Two Rivers Pit M-1998-038 AM-1 Decision Date Extension Needed

RE: Fremont Paving and Redi Mix, Inc. Two Rivers Pit M-1998-038 Amendment Application (AM-1), Second Adequacy Review

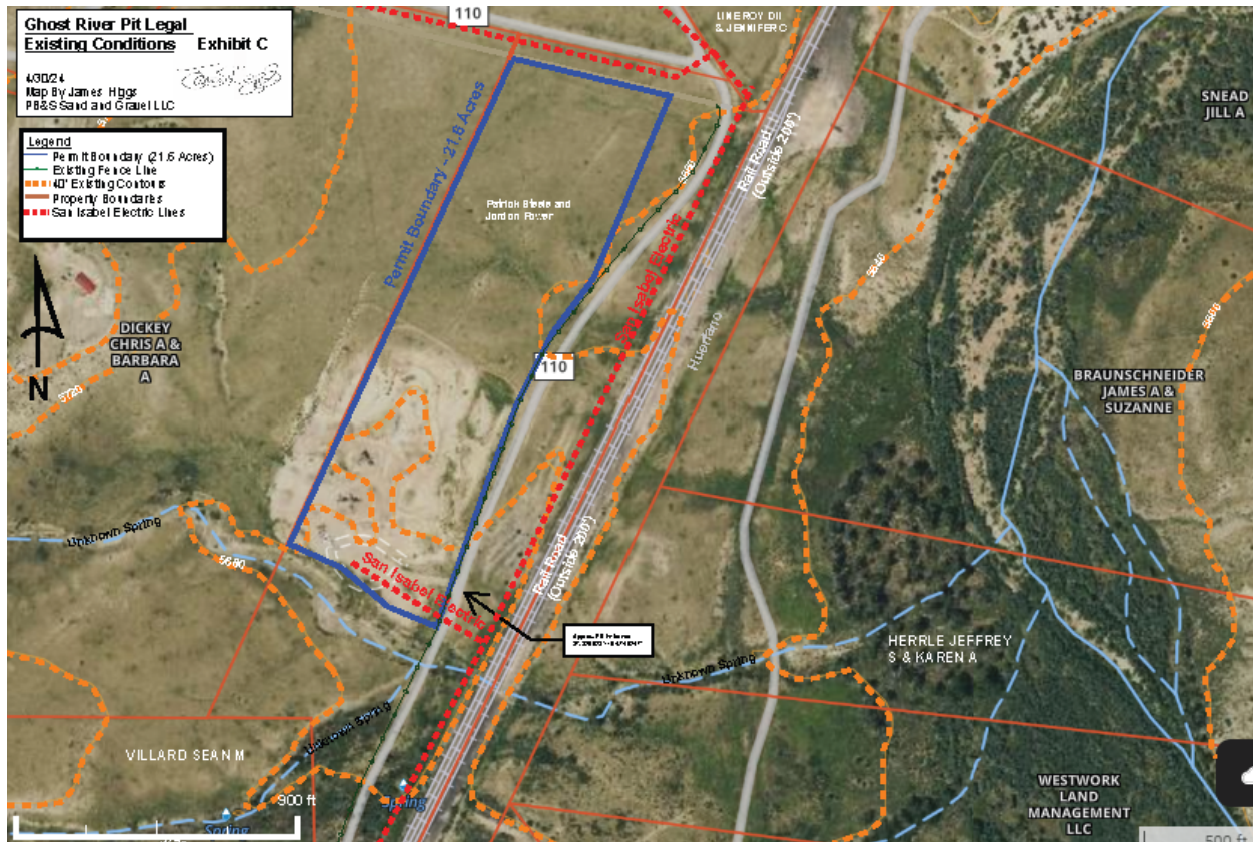
3. **The following is an additional issue:** A map was submitted with the preliminary adequacy response titled “Ghost River Pit Legal, Existing Conditions, Exhibit C”. This map does not appear to be associated with the Two Rivers Pit, Permit No. M-1989-038. Please confirm; the map in question is given below.
